**STATE OF KANSAS  
BEFORE THE DIVISION OF WATER RESOURCES  
KANSAS DEPARTMENT OF AGRICULTURE**

**Case No. 18 WATER 14014**

**Expert Report by Tim Boese  
for  
Equus Beds Groundwater Management District No. 2**

The City submitted to the Chief Engineer a proposal titled "ASR Permit Modification Proposal Revised Minimum Index Levels & Aquifer Maintenance Credits" (Proposal). The Proposal included a cover letter dated March 12, 2018, and also included supporting information. The Proposal requested that the following changes be made to the ASR Phase II approved water permits and also be applied to any pending or future ASR water permits:

**FIGURE 5**  
**FLOW ON LITTLE ARKANSAS RIVER AT VALLEY CENTER (USGS 07144200)**

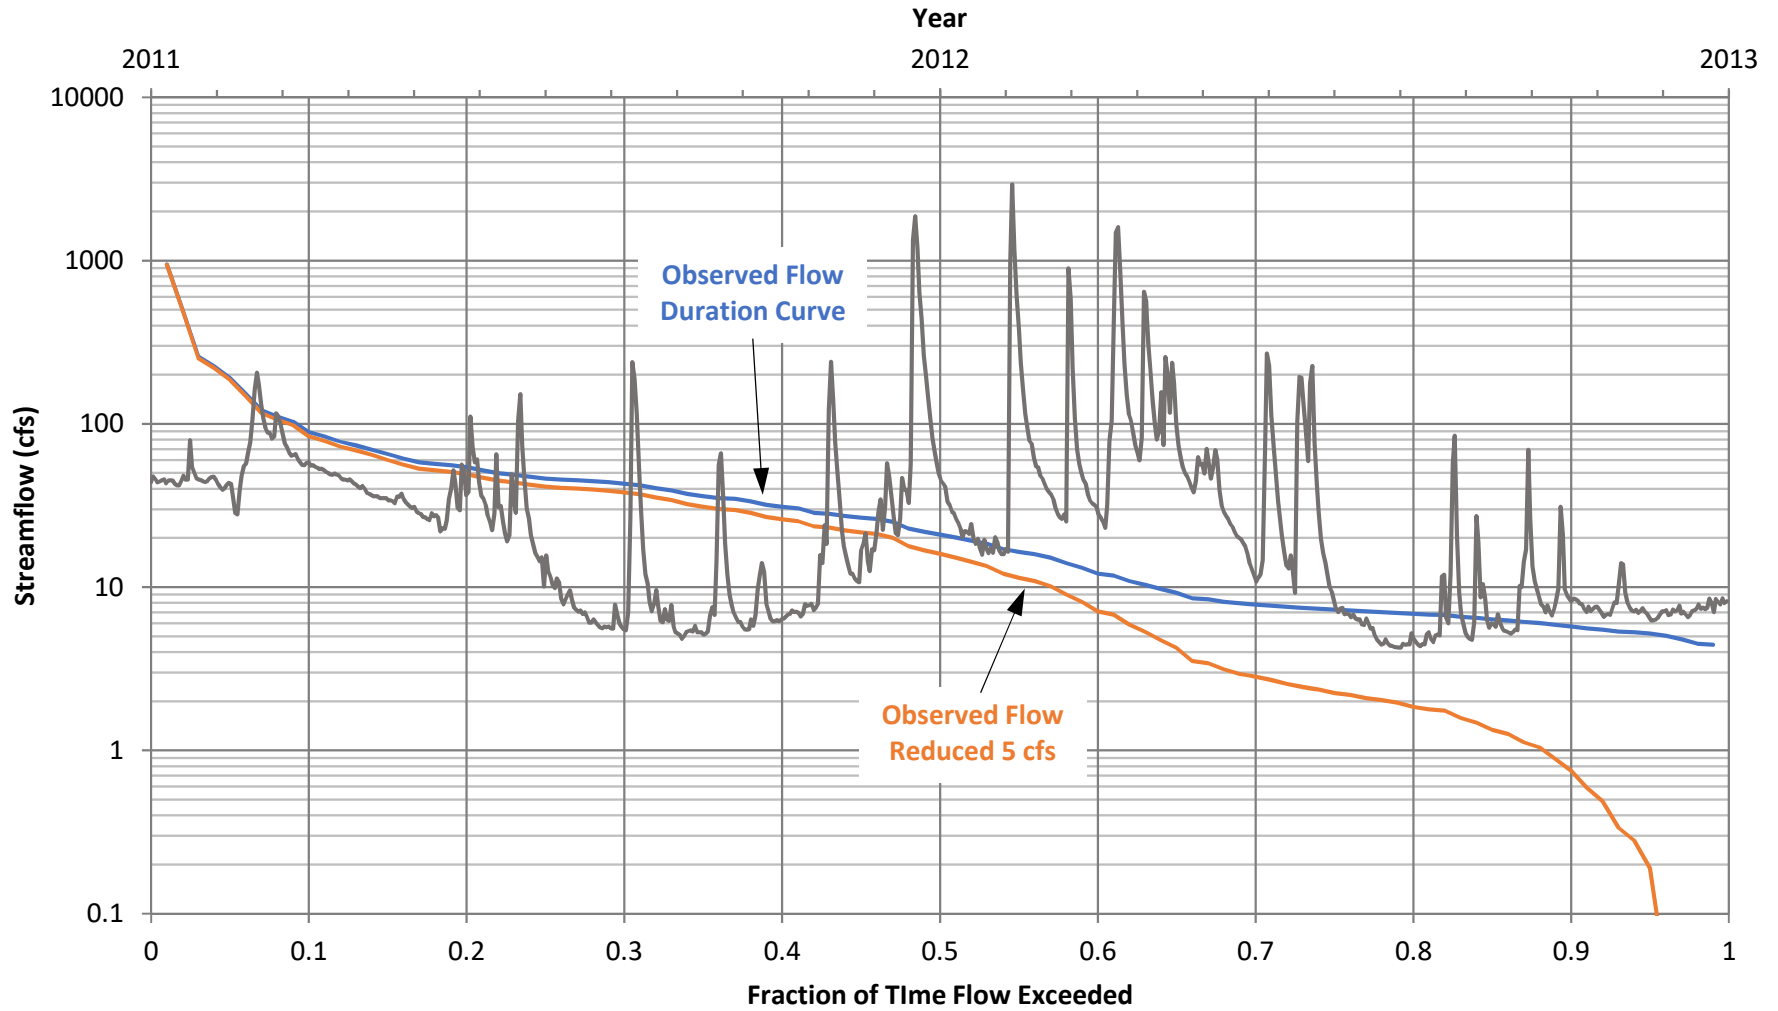
176 The minimum desirable streamflow (MDS) established at the gage on the Little Arkansas at  
177 Valley Center is 20 cfs.<sup>3</sup> **Figure 5** shows a chart of flow at that gage during the two years (2011 and  
178 2012) that characterize the 1% drought scenario. During that time, flow at the gage is below 20 cfs  
179 49 percent of the time. A change in flow of 5 cfs at that gage (assuming about half of the impact  
180 occurs on the Arkansas River) during the drought, would impact MDS flow so that it is less than 20  
181 cfs about 53 percent of the time (**Figure 5**). The percentages translate to about one month of MDS  
182 flow not met due to drawing down water levels from the current minimum index level to the  
183 proposed level.

**WATER-LEVEL DRAWDOWN FROM SCENARIOS A, B and C**  
**FIGURE 6**

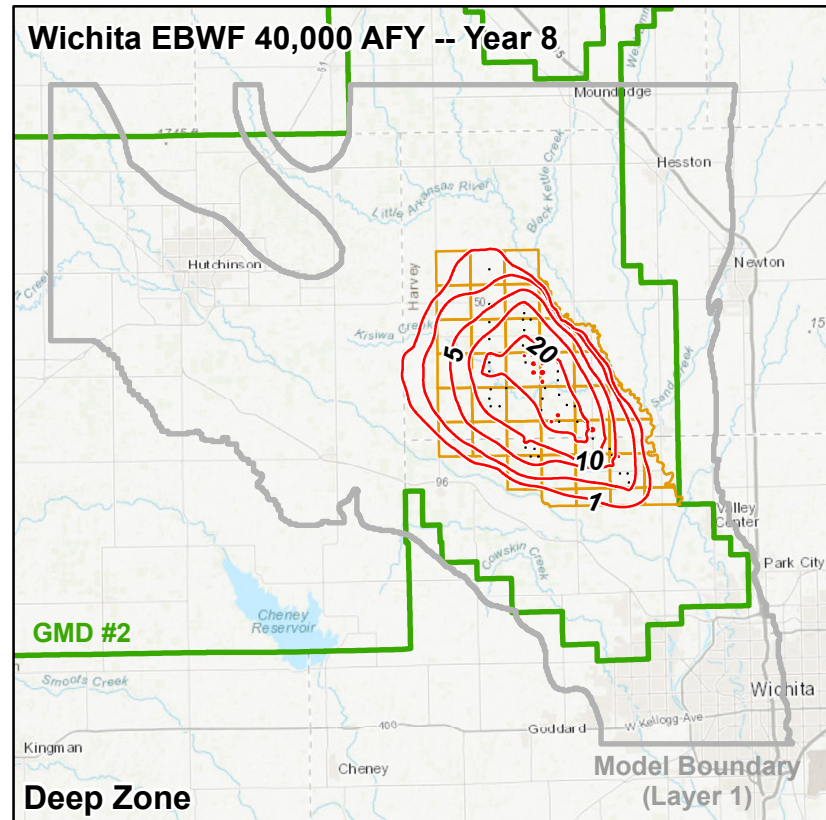
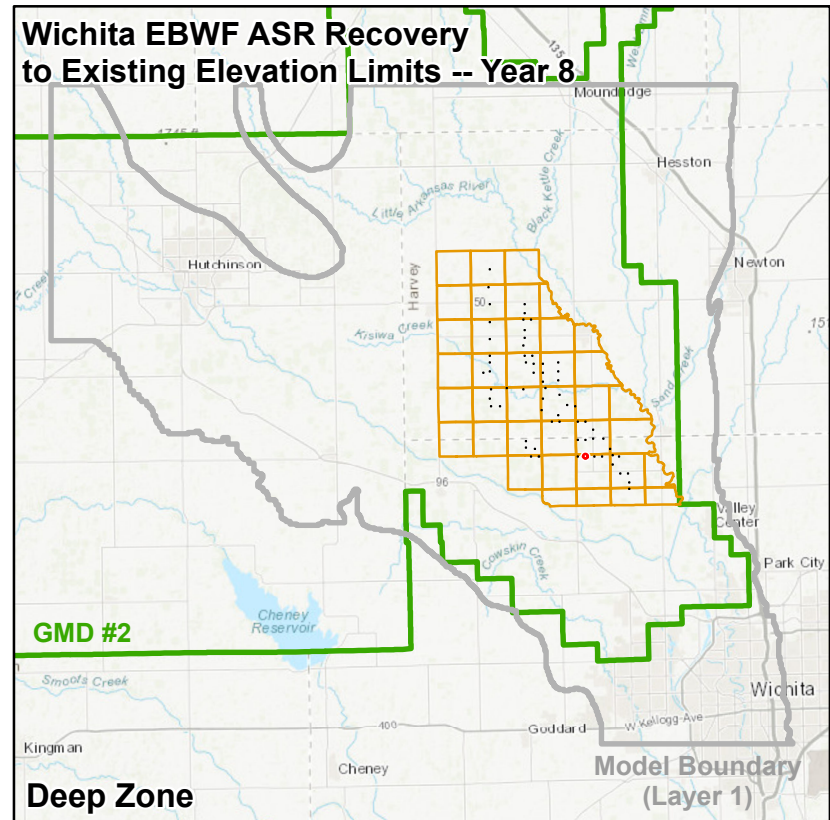
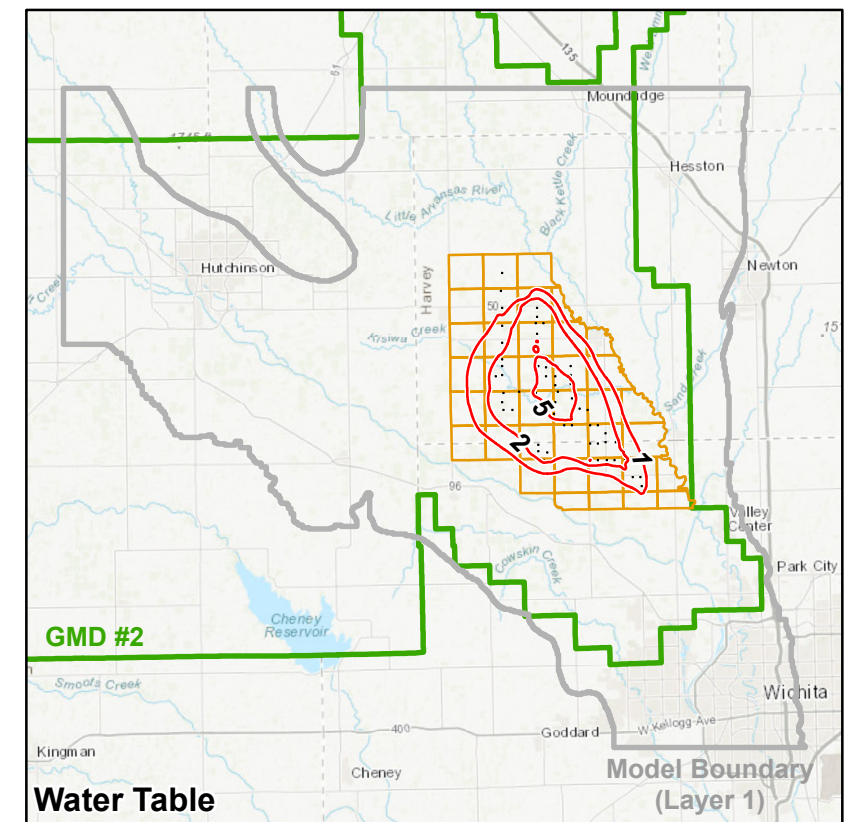
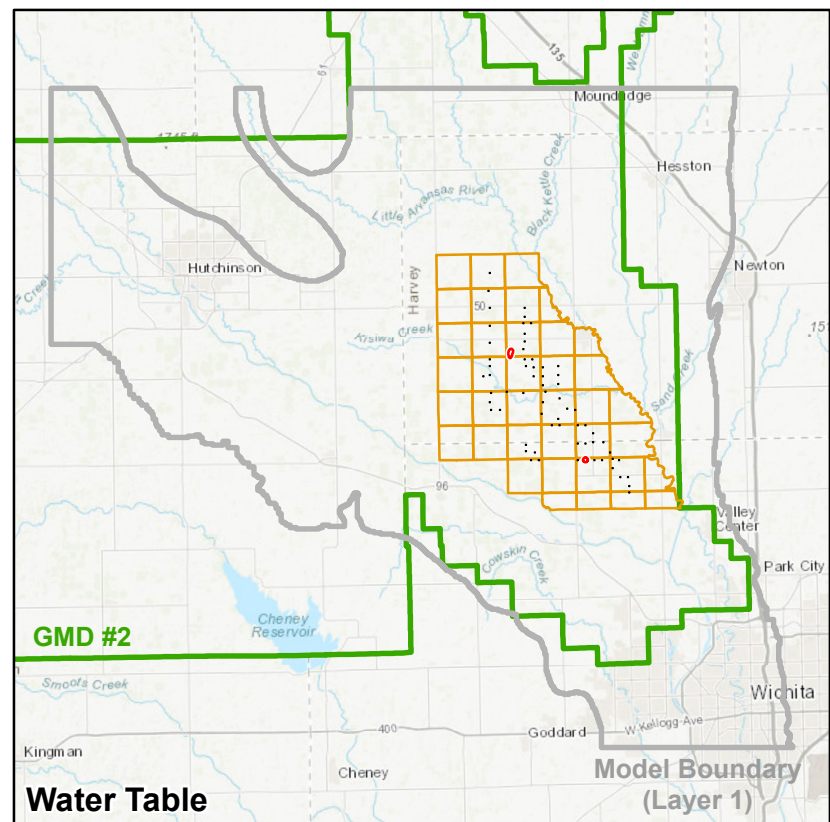
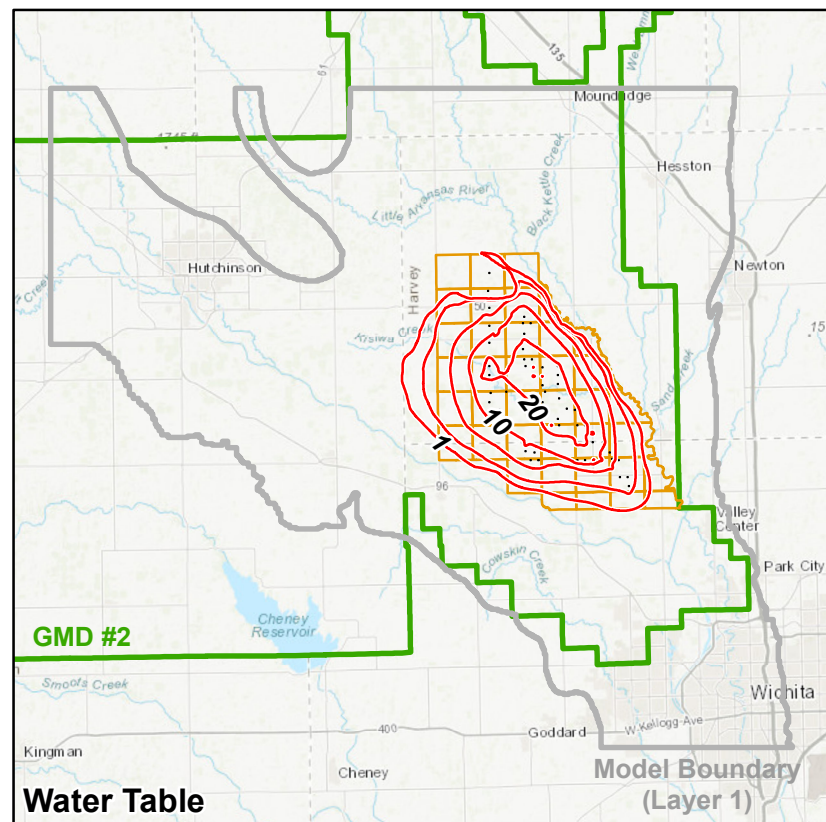
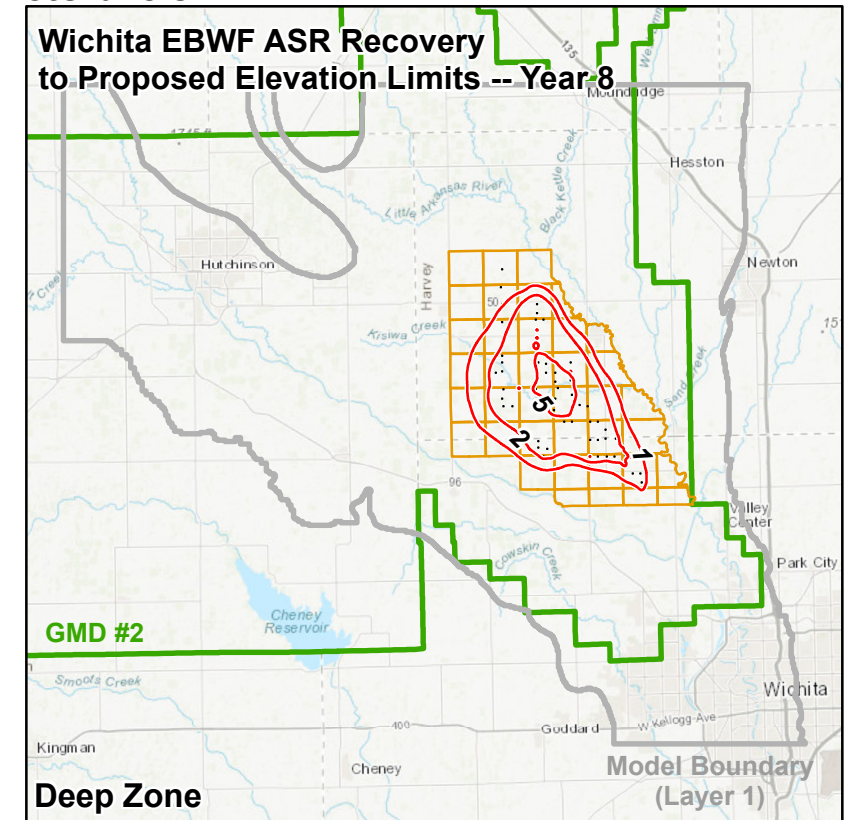
<sup>4</sup> On Figure 6, Scenario B shows generally less than 1 foot of drawdown in most of the BSA.

**FIGURE 7**

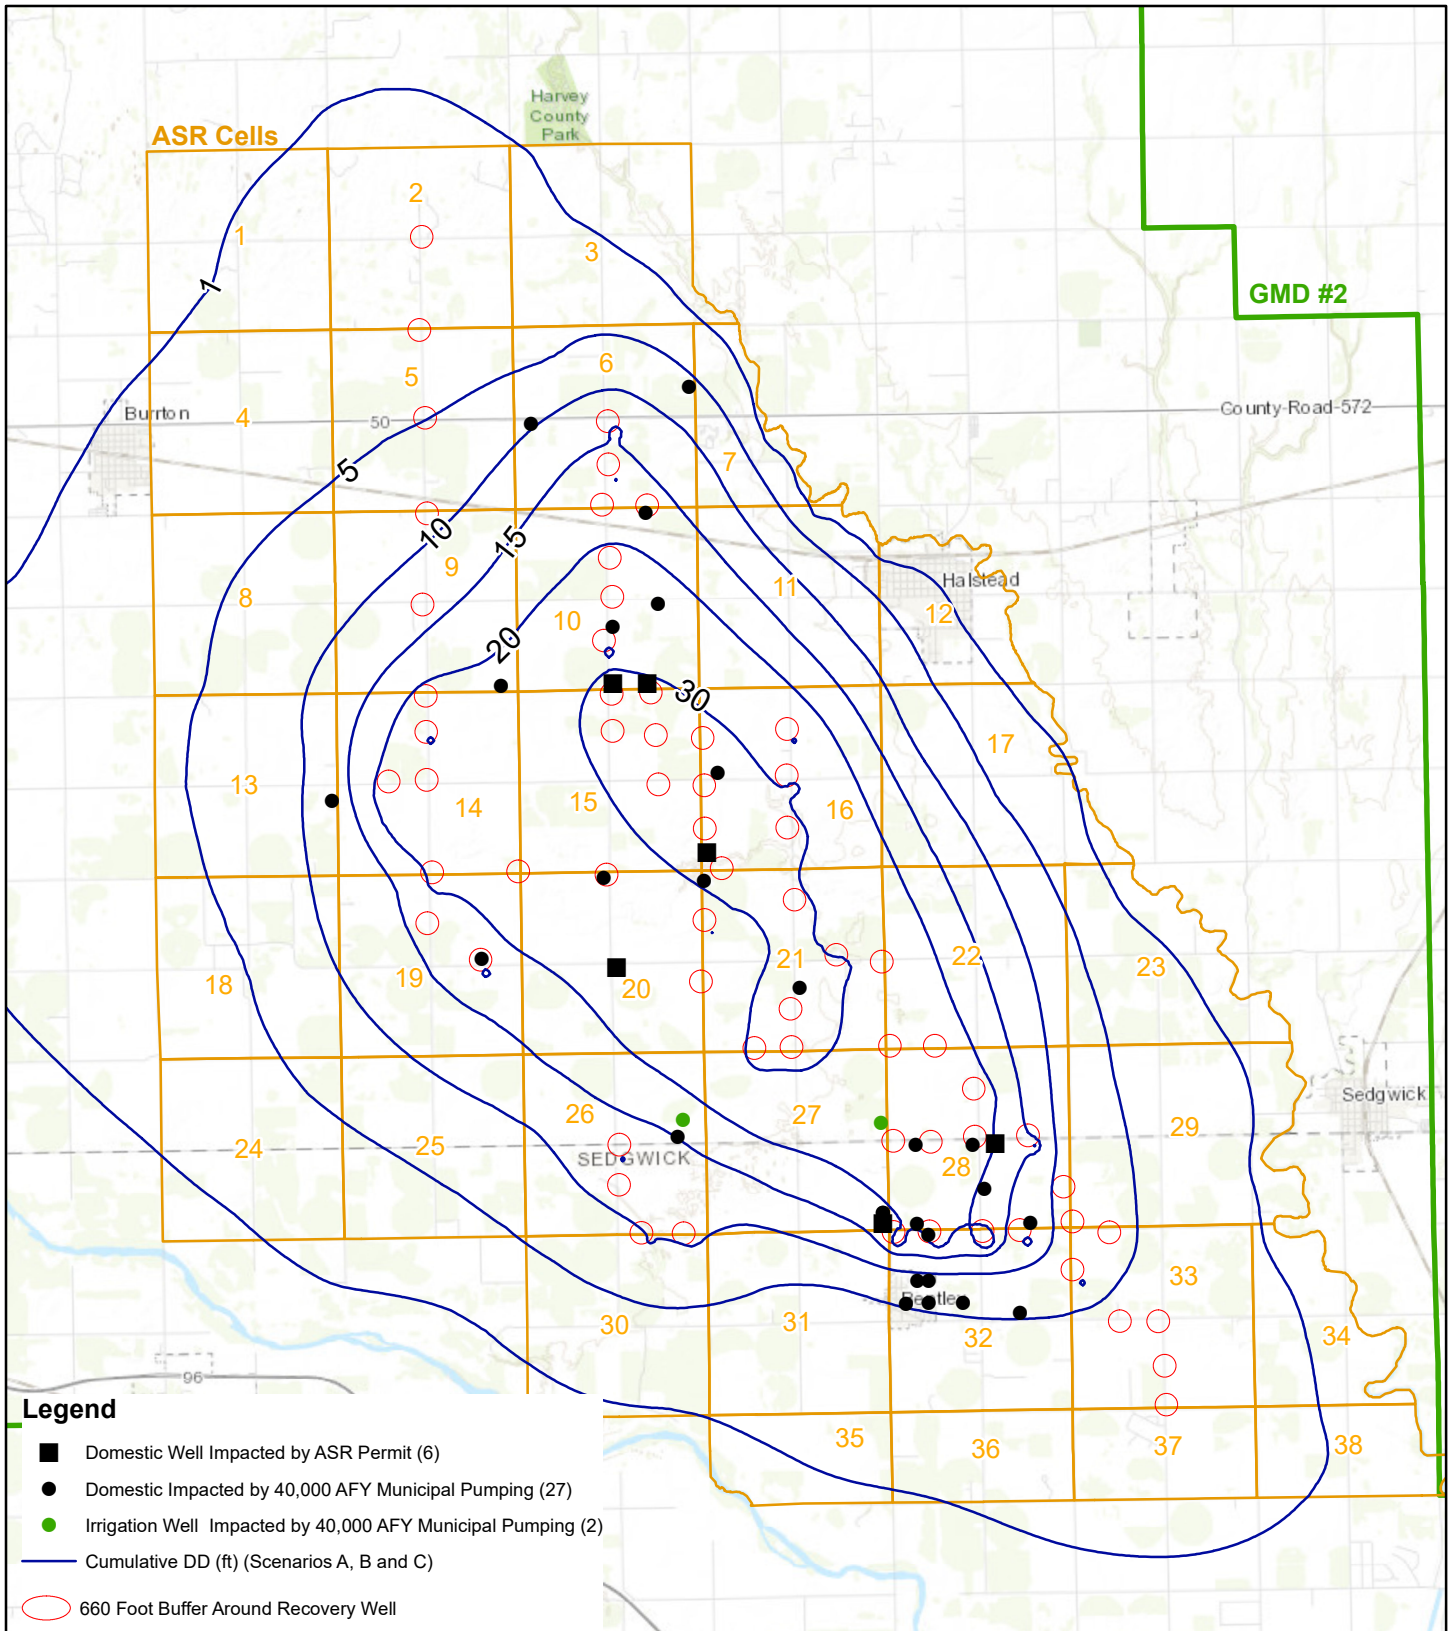
237 **Figure 7** shows the locations of City wells as red circles. The red circles represent the  
238 location of the well and a 660-foot buffer around the well location. We note that out of the wells  
239 potentially impacted, many of them are located at distances greater than 660 feet from the City  
240 wells. This indicates that the minimum well spacing regulation (K.A.R. 5-22-2) for domestic wells  
241 (660 feet), from other wells in a subject application, is not sufficient to provide protection from
